Saab 9-3 - Loss of coolant | HELLA

Engine code: B284.

Loss of coolant

Figure 1

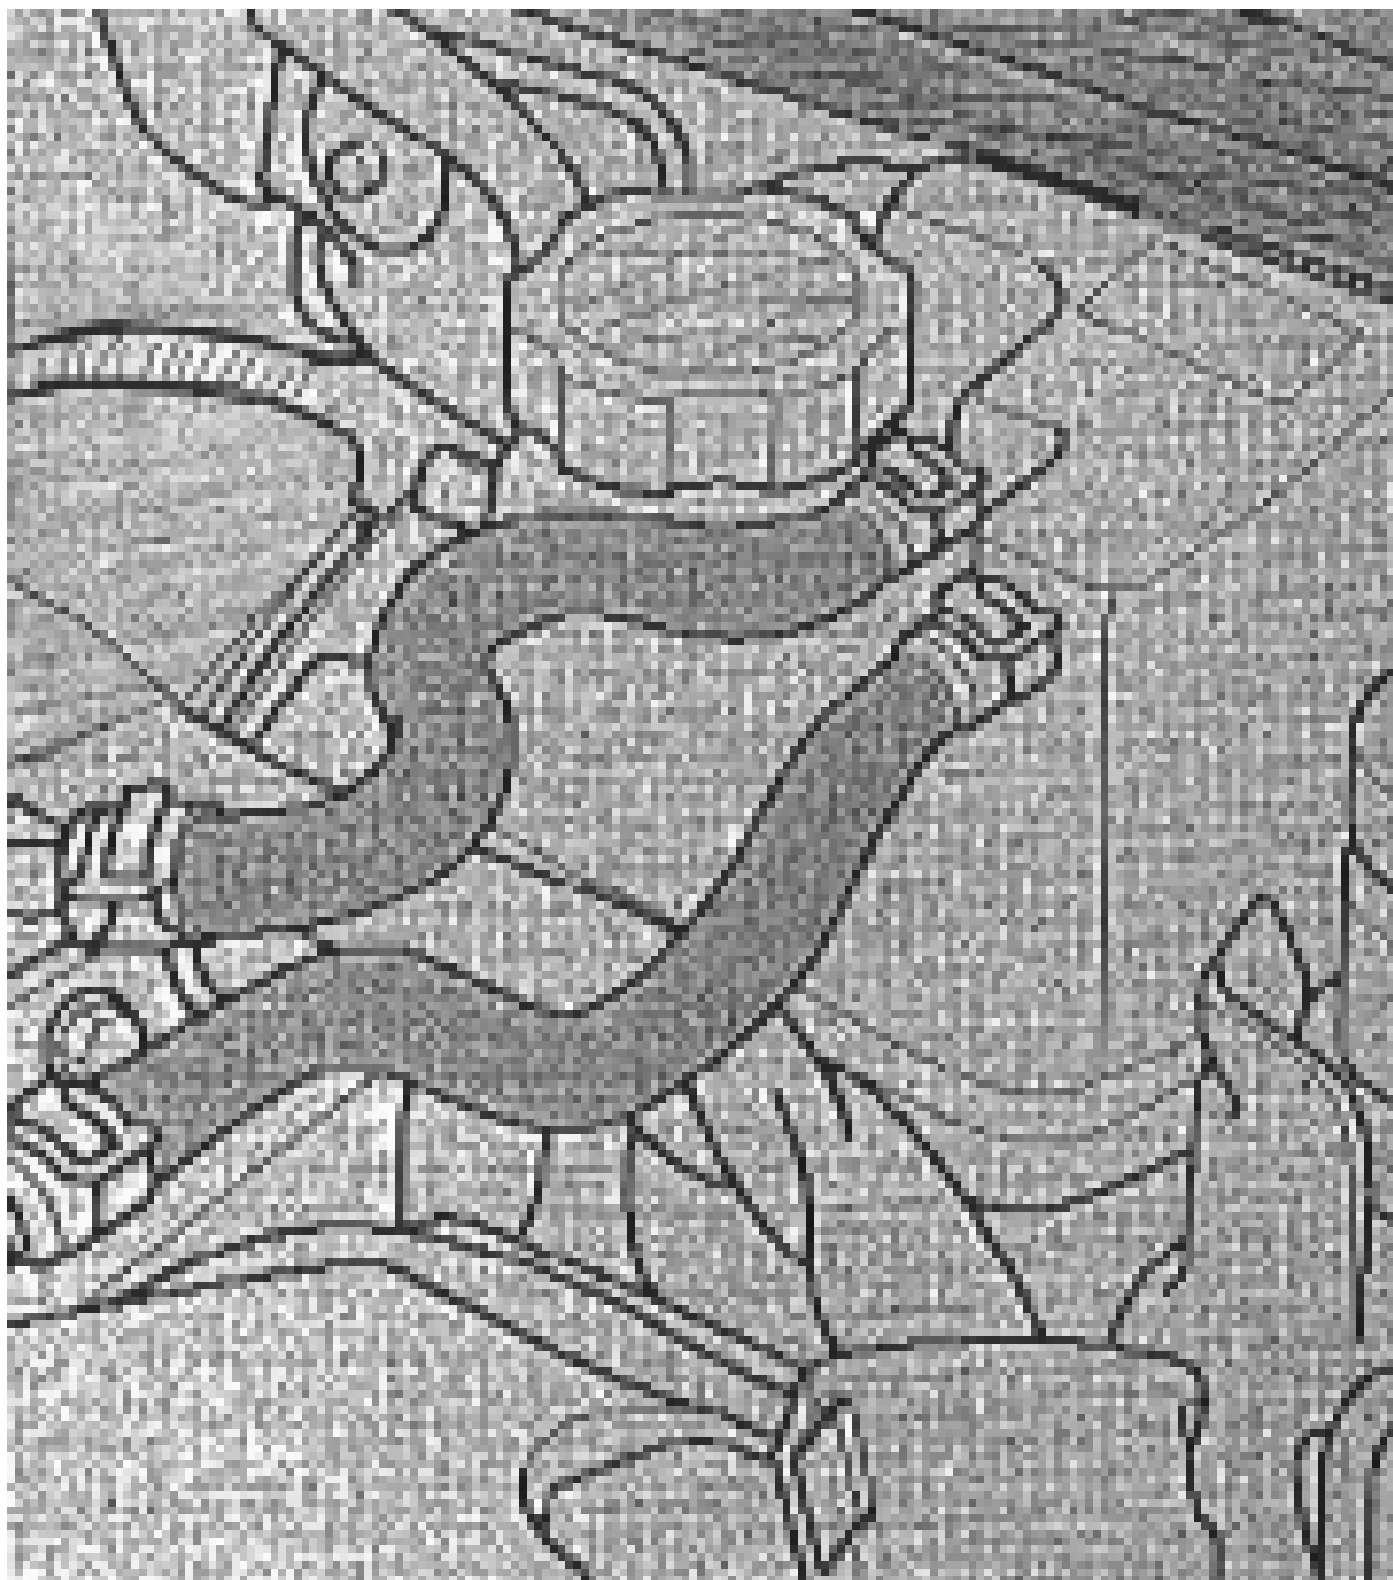
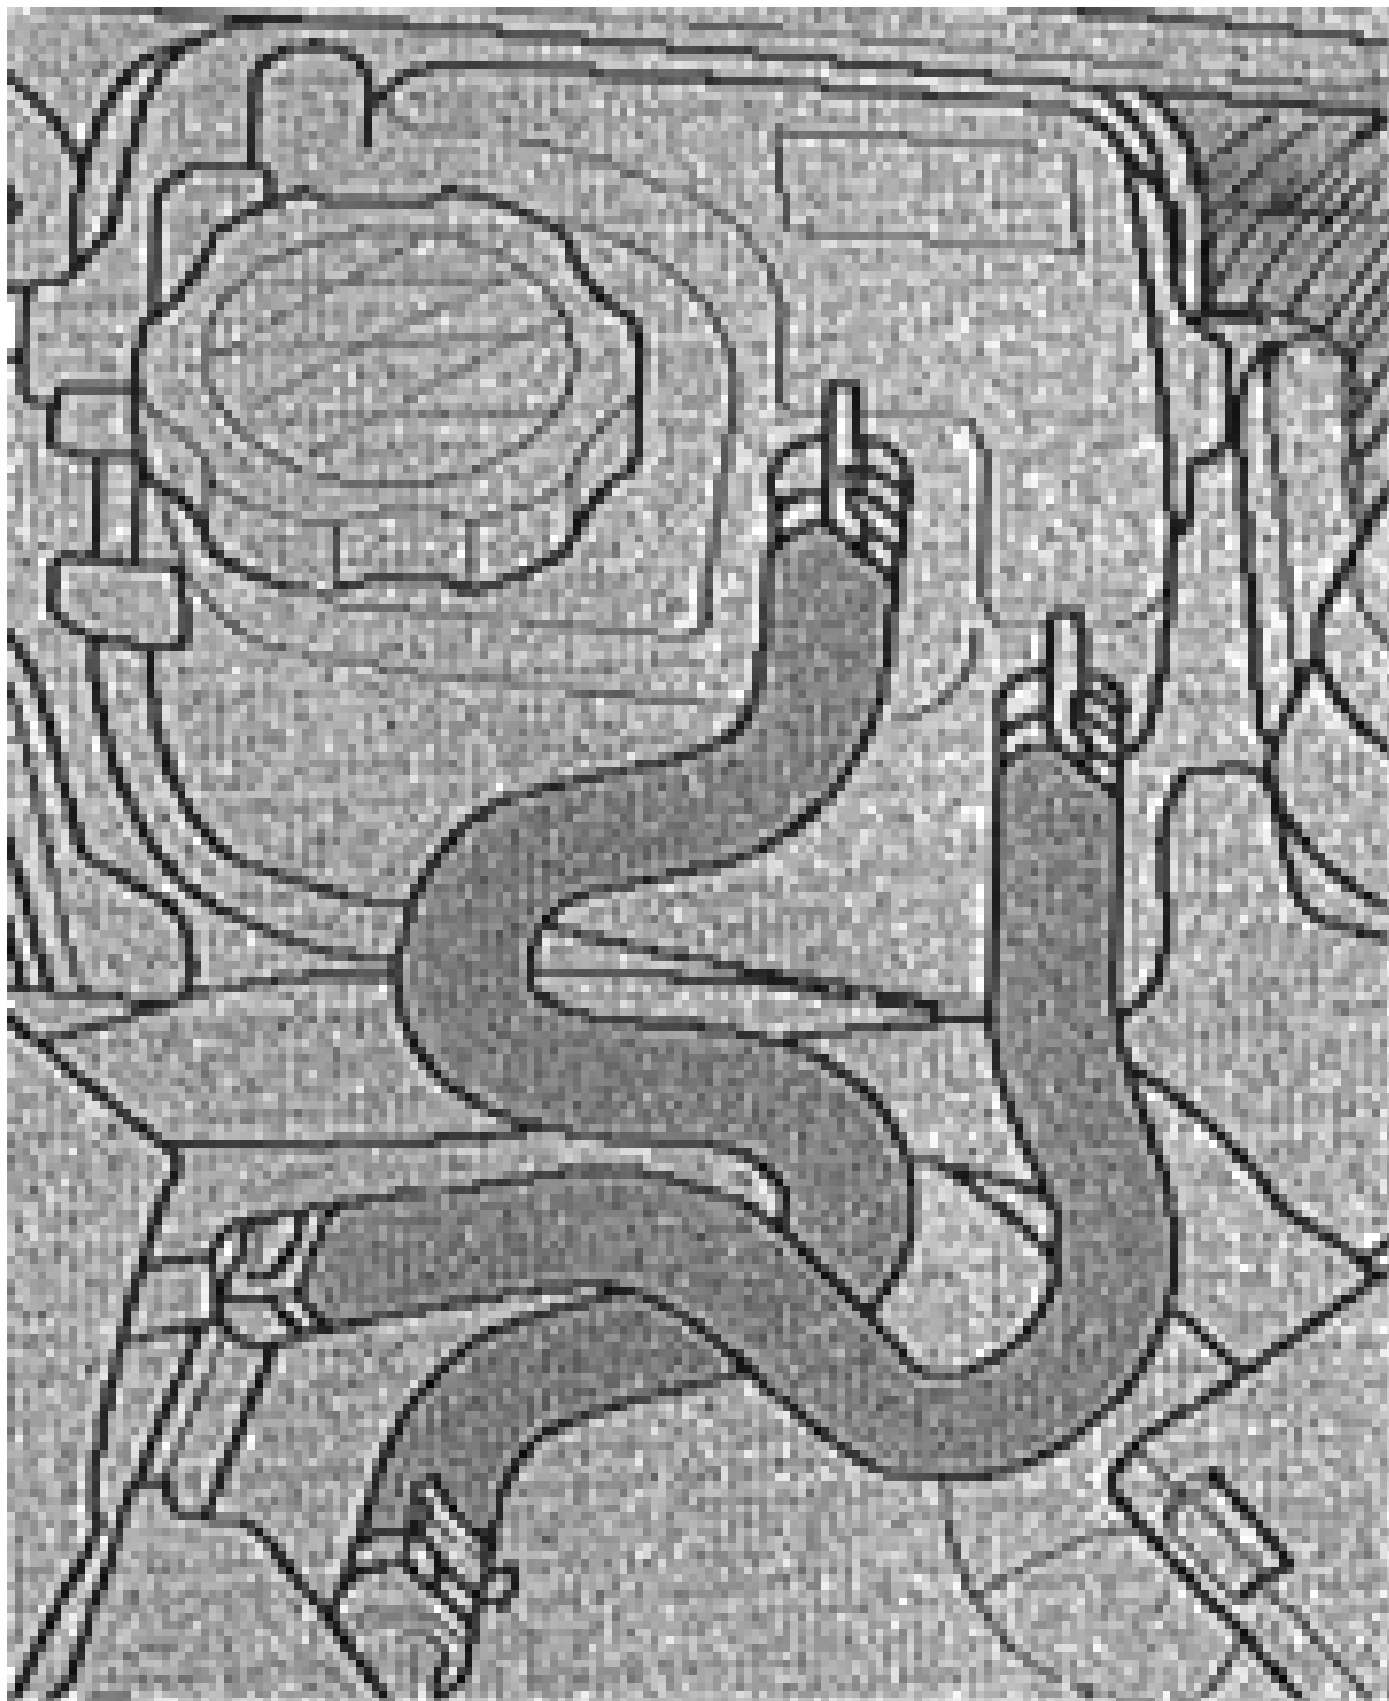
In the case of the above-mentioned vehicles, problems can arise because of loss of coolant. The cause of this can either be a defective coolant expansion tank or damaged engine coolant hoses on the coolant expansion tank.

The positioning of these components (Figure 1) is located very close to the turbo charger, which means that material fatigue can result because of the hot ambient temperature.

In order to remedy this, the coolant expansion tank is to be replaced and the hoses of the coolant expansion tank are also to be replaced / repositioned.

The car manufacturer provides modified coolant hoses for this specific purpose (See Figure 2).

Spare part no: 93 194 927

Spare part no:12 759 330
